GOVERNMENT OF THE DISTRICT OF COLUMBIA  
DEPARTMENT OF GENERAL SERVICES

METROPOLITAN POLICE DEPARTMENT (MPD) 7<sup>TH</sup> DISTRICT  
LOCKER ROOM RENOVATIONS

Solicitation No.: DCAM-15-CS-0083

Amendment No. 2  
Issued: February 13, 2015

Exhibit 2B

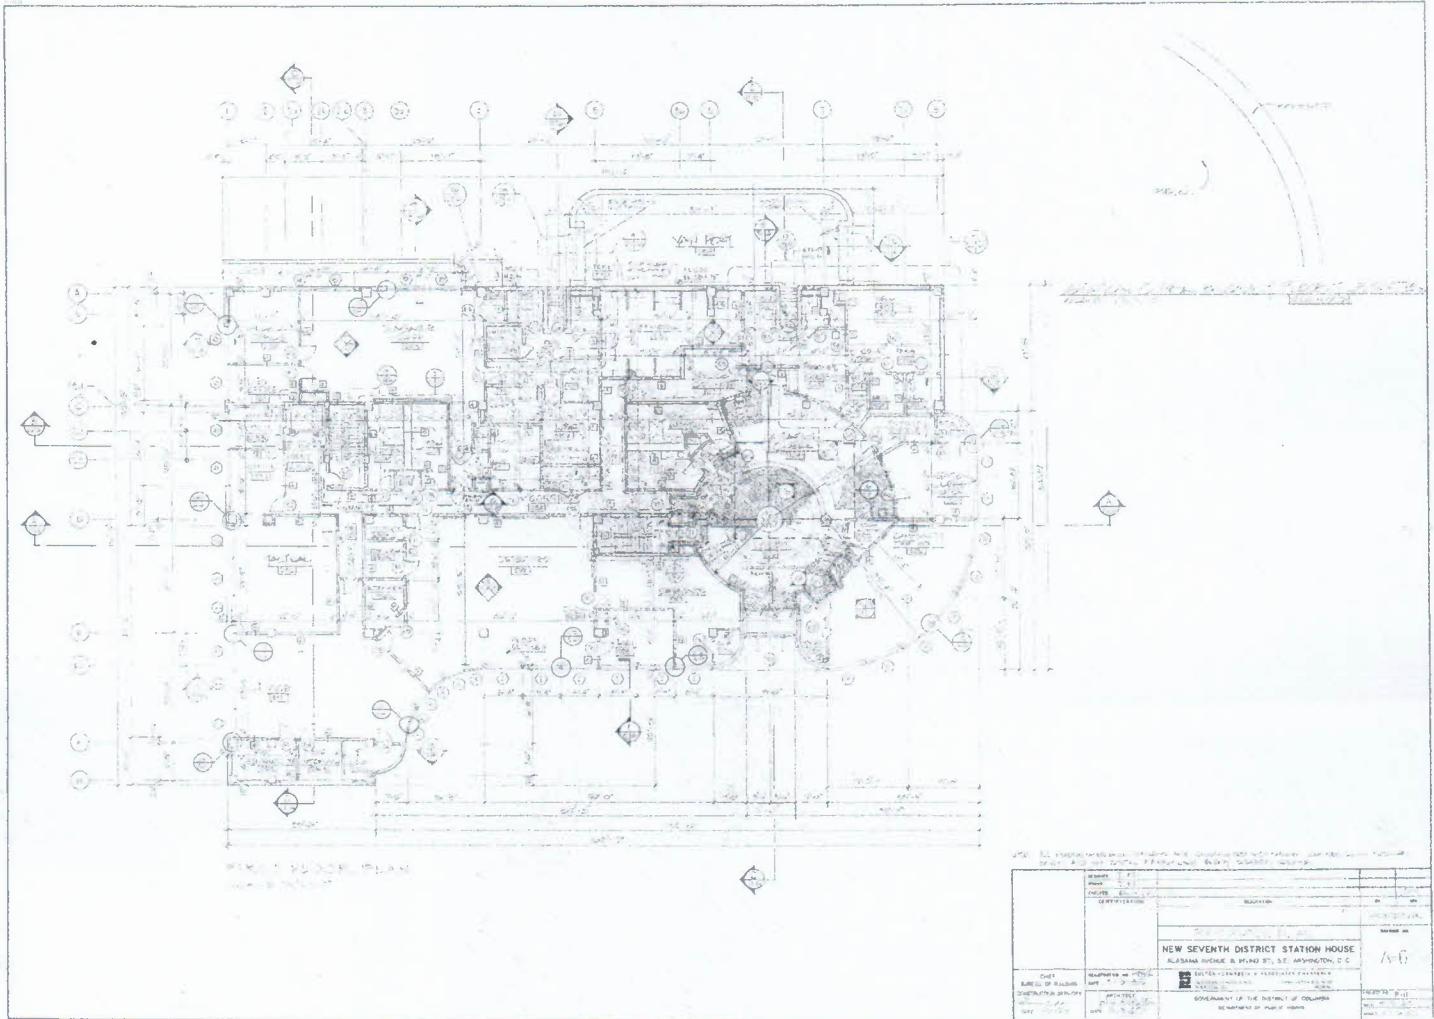
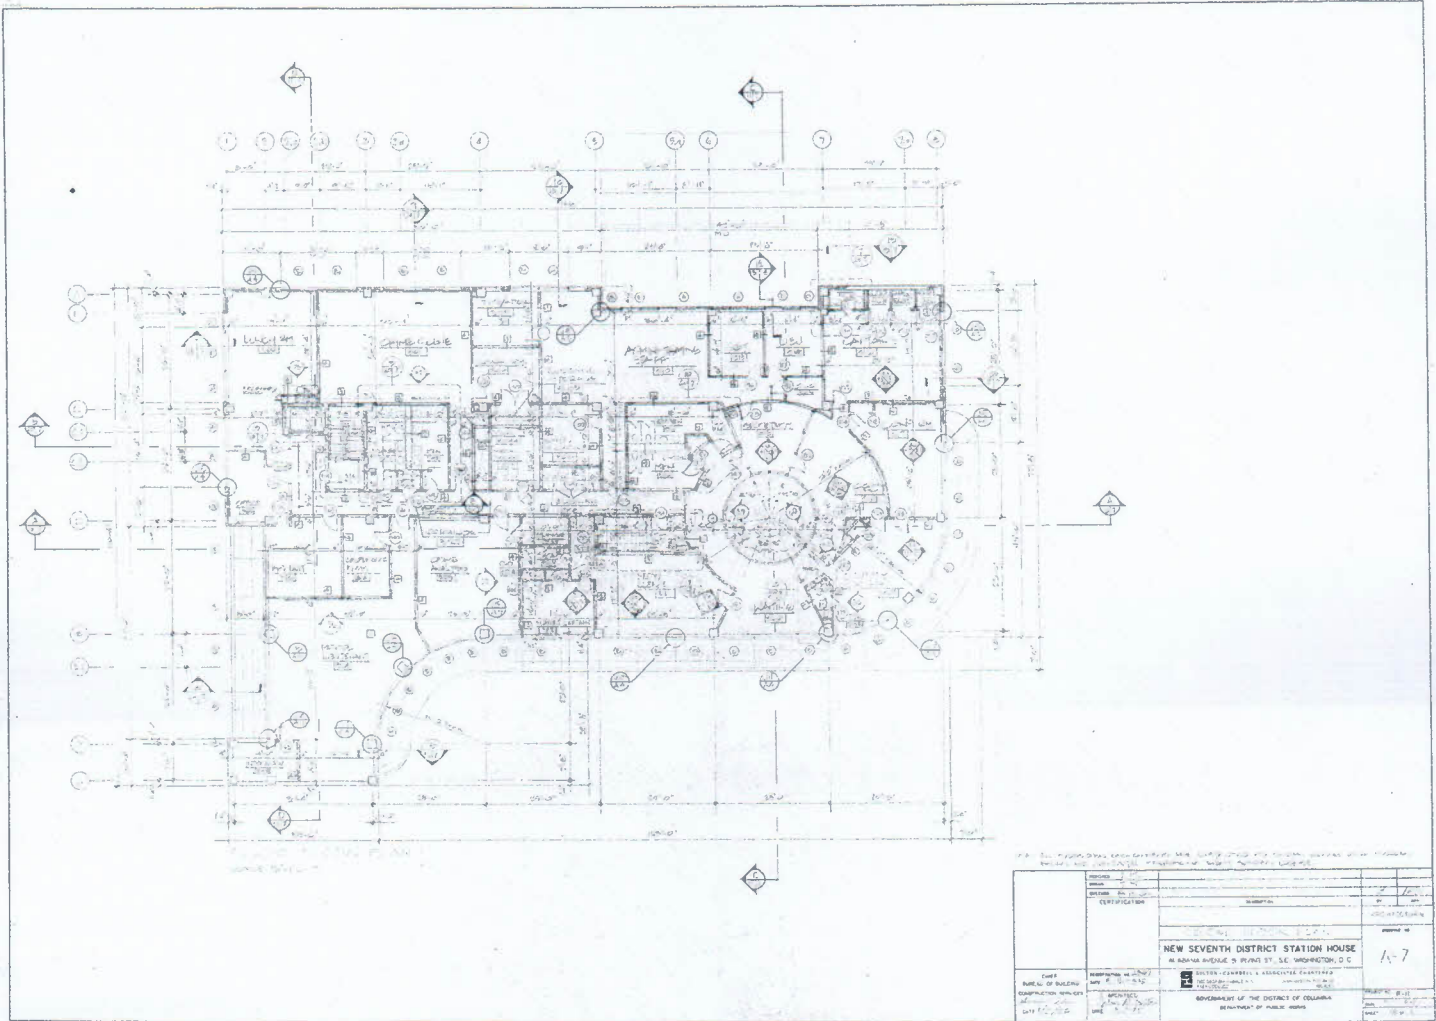
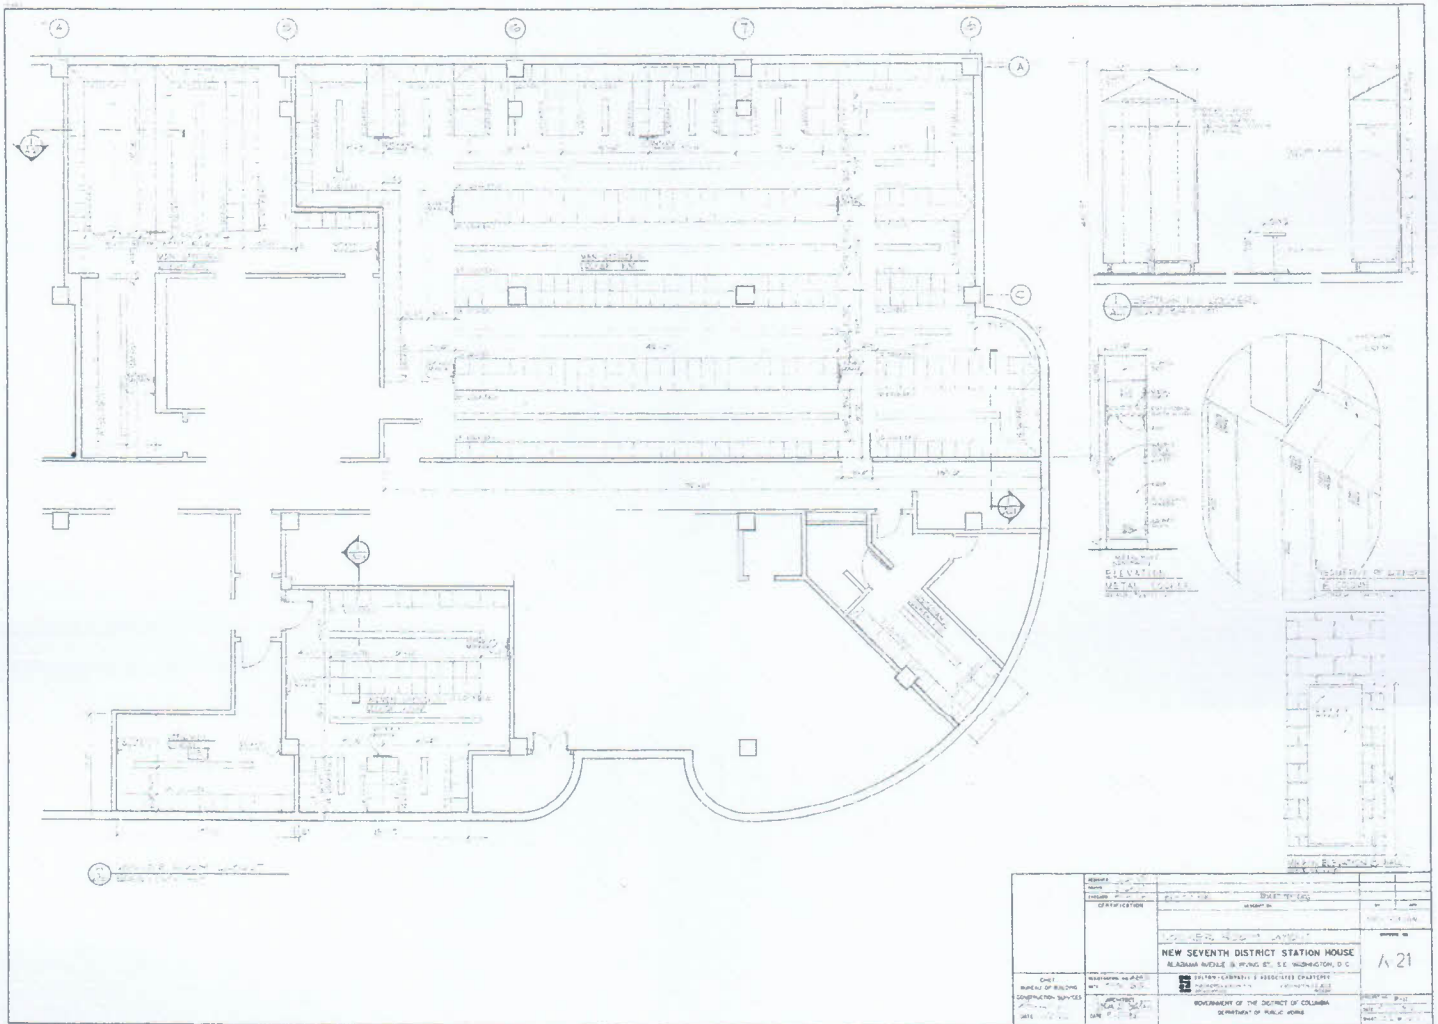
Q-5. Please provide circuit panel locations and wiring diagram to verify load capability.

**Wiring diagrams are not available. Panel locations are noted on the Archive Drawings included as Exhibit 2B to this Amendment. The existing fixtures are being replaced so there should be no additional loads on the existing panels.**
